BRIDGE REPAIR
FN-3-5(34)--21-12

PLANS OF PROPOSED IMPROVEMENT ON THE
PRIMARY ROAD SYSTEM
BUTLER COUNTY
BRIDGE REPAIR

IOWA 3 OVER HARTGRAVES CREEK OVERFLOW W. OF DUMONT

DESIGN FOR REPAIR TO A

PART LONGITUDINAL SECTION ALONG ROADWAY

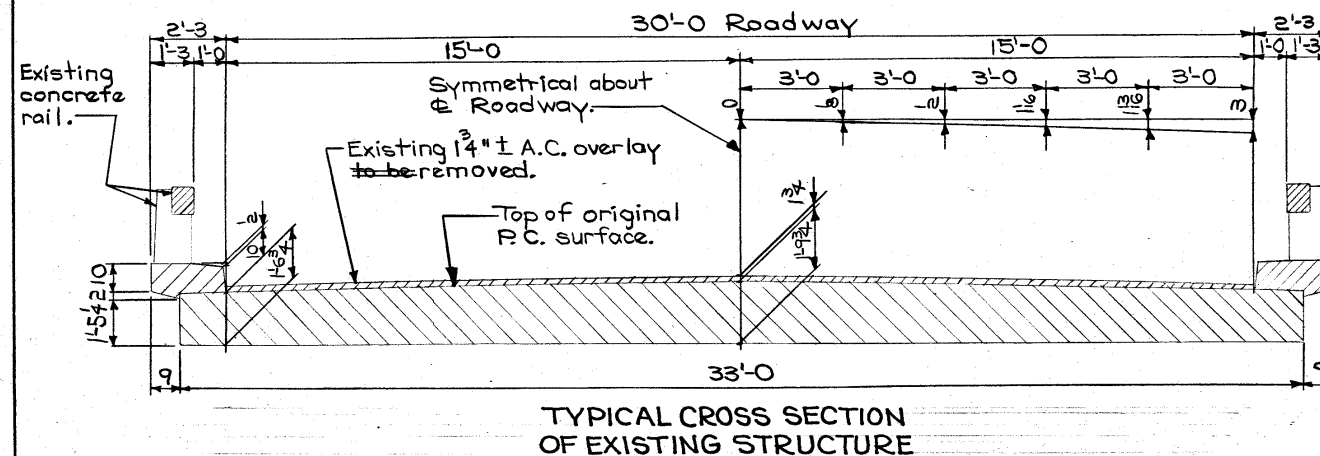
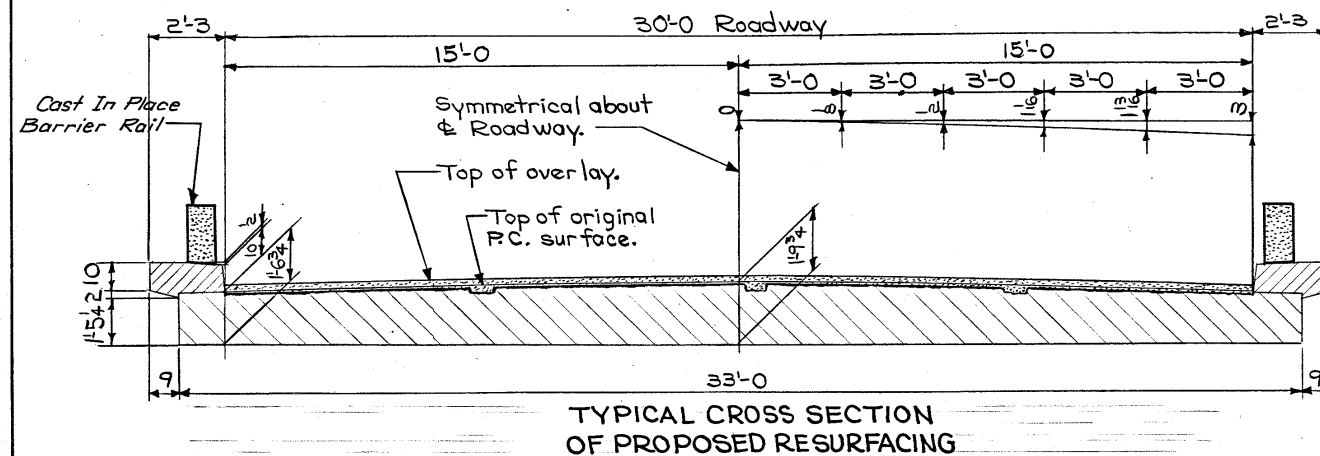
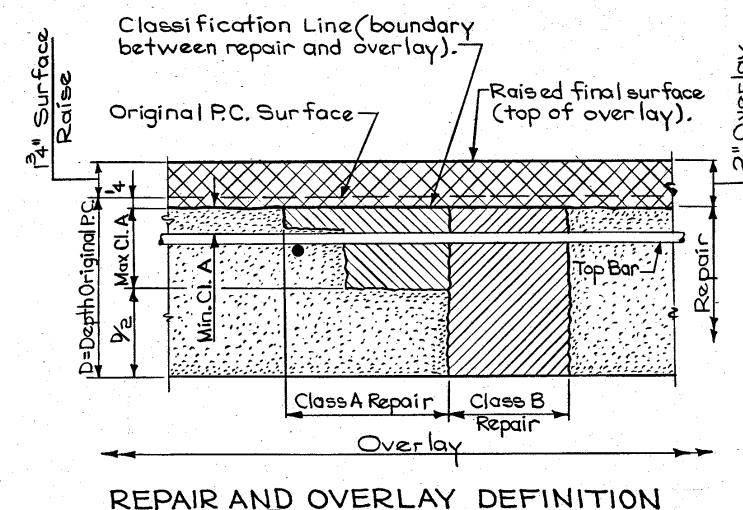
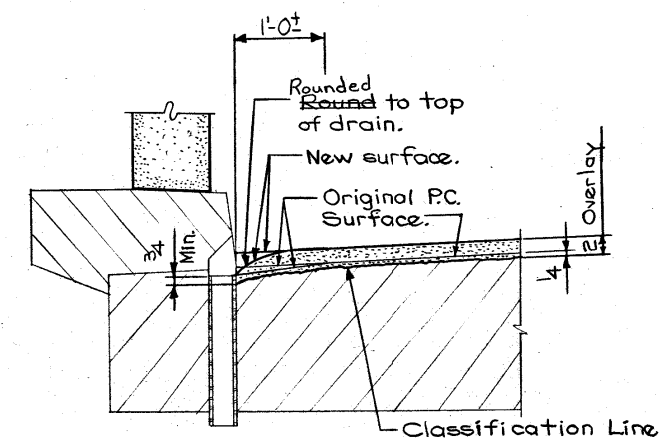
The Contractor ~~may~~ removed a minimum of the existing approach pavement and overlay to facilitate construction of the floor overlay. This A.C. ~~shall~~ be replaced by others.

The Contractor ~~may~~ removed a minimum of the existing approach pavement and overlay to facilitate construction of the floor overlay. This A.C. ~~shall~~ be replaced by others.

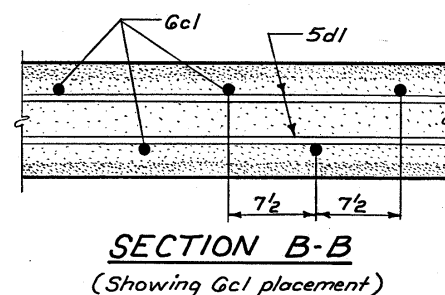
NOTE: On each side of bridge, Dimension "X" ^{was 3"} ~~can be a minimum of 1" and a maximum of 3", but must be constant for full length of bridge.~~

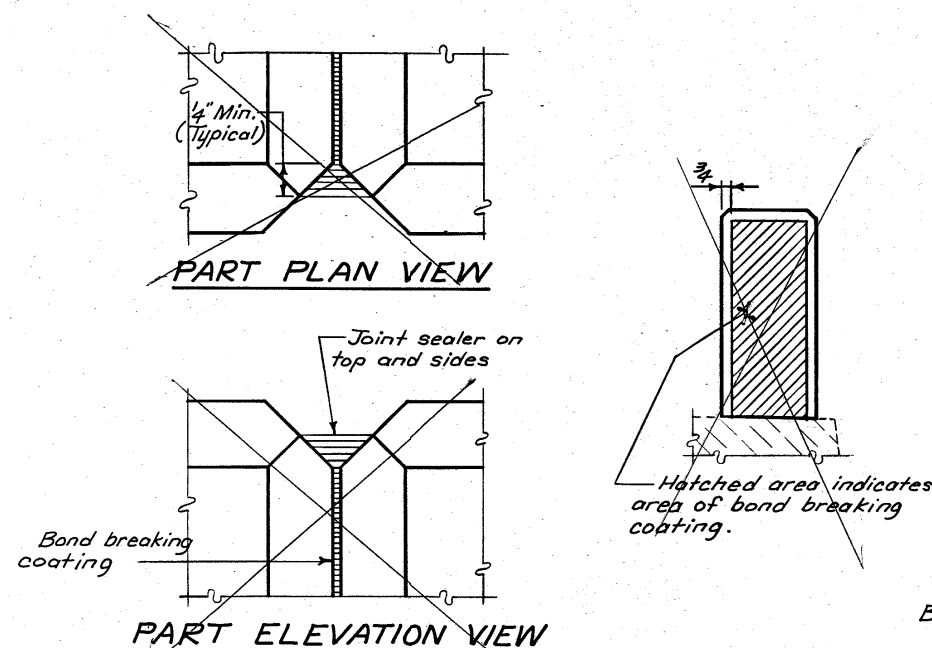
NOTE: The existing end posts, wings and rail posts ^{were} ~~are to be removed down to top of curb. The existing reinf. bars in the portion of the curb and wings shall be cut off flush with the curb and wing surfaces and the remaining exposed ends shall be painted with two coats of zinc rich paint. Cost is to be included in the price bid for "Removals As Per Plan".~~

CAST IN PLACE BARRIER RAIL JOINT DETAILS

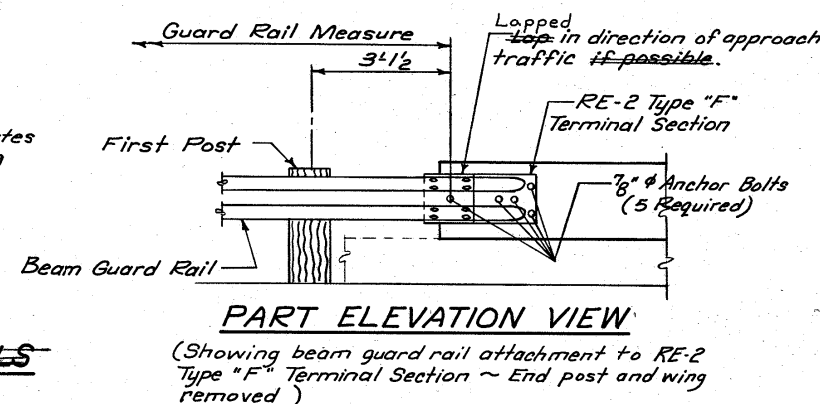
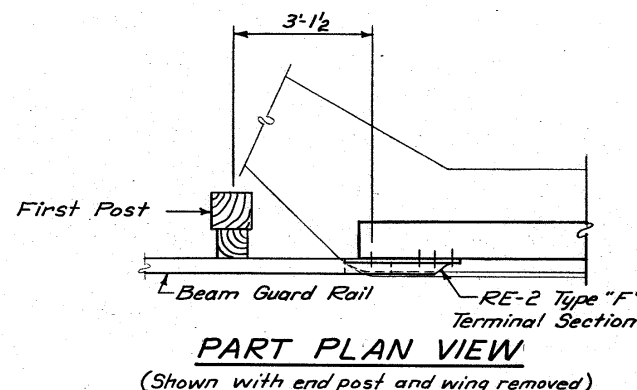
DOWEL SETTING NOTE
THE GCL BARS ^{WERE} ~~SHALL BE~~ SET AS DOWELS IN DRILLED HOLES. HOLES ^{WERE} ~~SHALL BE~~ 10" DEEP. THE DOWELS ^{WERE} ~~SHALL BE~~ INSTALLED IN ACCORDANCE WITH THE MANUFACTURER'S RECOMMENDATIONS. ^{ONE OF THE TWO} ~~ONE OF THE TWO~~ FOLLOWING SYSTEMS ^{WAS} ~~SHALL BE~~ USED AS A BONDING AGENT FOR THE DOWELS:
1) EPOXY SYSTEM. DRILLED HOLES ^{WERE} ~~SHALL BE~~ 7" Ø. THE EPOXY GROUT ^{WAS} ~~SHALL BE~~ ONE OF THOSE APPROVED IN THE IOWA D.O.T. MATERIALS I.M. 491.11.
2) GROUT SYSTEM. DRILLED HOLES ^{WERE} ~~SHALL BE~~ 2" Ø. THE HYDRAULIC CEMENT GROUT ^{WAS} ~~SHALL BE~~ ONE OF THOSE APPROVED IN MATERIALS I.M. 491.13.
